TOUCH BOARD rev D (decision 5A): 4 electrodes + AT42QT1070, one HOST wire-pad set; replaces rev C in the chin seat

Title: HA panel touch board rev D

Size: A4	Date: 2026-11-07	**Rev: D**
KiCad E.D.A. 9.0.9		Id: 1/1

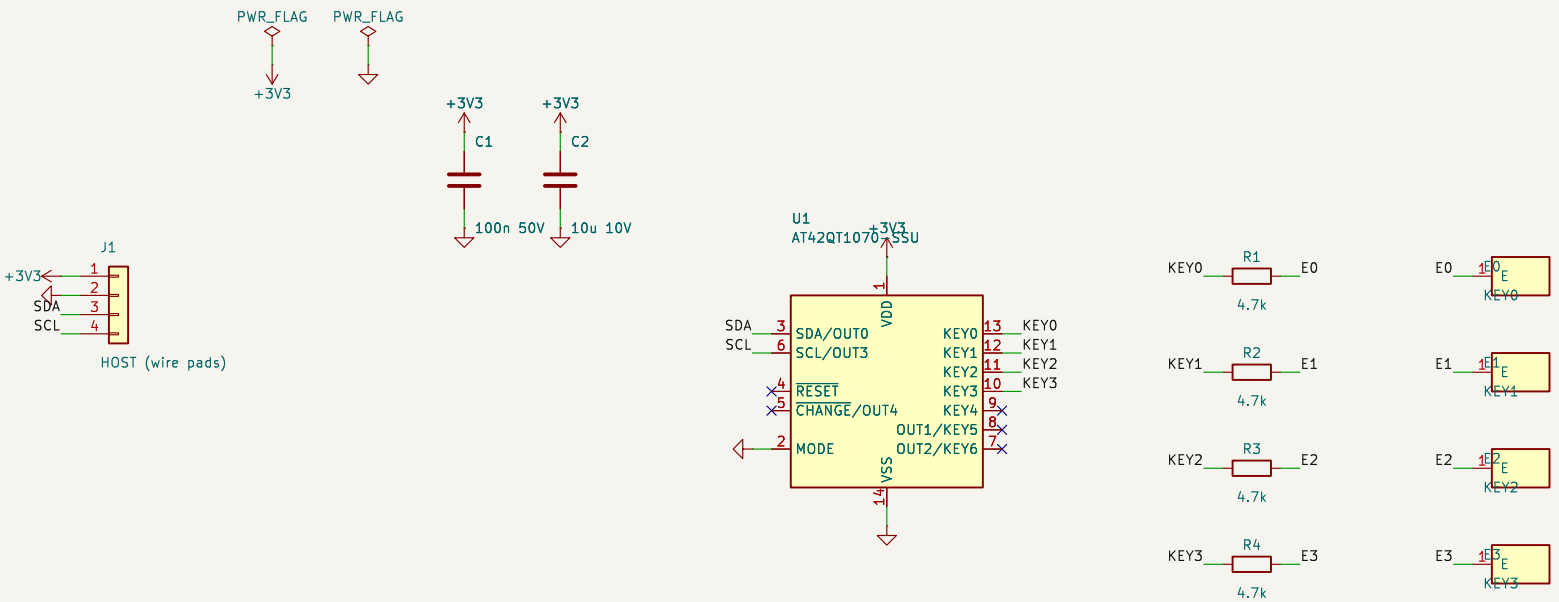
AT42QT1070 (Atmel 9596C-AT42-05/2013): key outline 6 x 6 mm or larger (panel thickness dependent); plastic panels up to 5 mm;
Cx 1-30 pF per key; MODE = GND selects comms mode (rev A root cause); no pull-ups here (host 1.8 k on the Pi).
Electrodes 16 x 16 mm (rev C: Ø12); QTAN0062 2.3 - electrode dimension >= 4 x panel thickness; panel = 2.5 wall + 0.7 cloth
= 3.2 mm (rev F model, not measured) -> >= 12.8 mm. Centres unchanged from rev F: front-view X 9/33/57/81, Y 13.
Board 90 x 44 x 1.6 (rev F seat), no holes except tented vias; front = electrodes only; all parts and the HOST pads on the back.
BME680 / VEML6030 leads now land on the main board (J10); VL53L0X cluster dropped.

Replaces hardware/rev-c (unchanged, kept for reference)
Decision 5A (Daniel 2026-11-07): same 90 x 44 outline, electrodes + AT42QT1070 + HOST pads
KiCad 9.0.9 - generated by hardware/main-board/gen/touch_board.py
HA panel (neocleous/ha-panel)
